June 7, 2019

6/5/2019 Red Oak grass cutters reported a bulge on the back of the dam. They said there is an area that is steeper than it used to be.

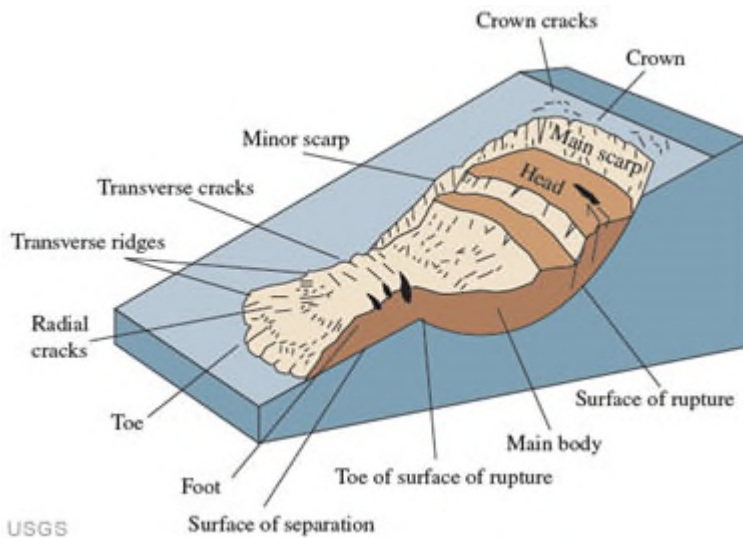
FLAG LINE MARKING LOWER LIMIT OF "BULGE" AREA WAS ON SAME LINE AS WHERE BACK OF DAM HAS ALWAYS CHANGED STEEPNESS. HORIZONTAL RUTS FROM GRASS CUTTING MOWERS COULD BE SEEN.
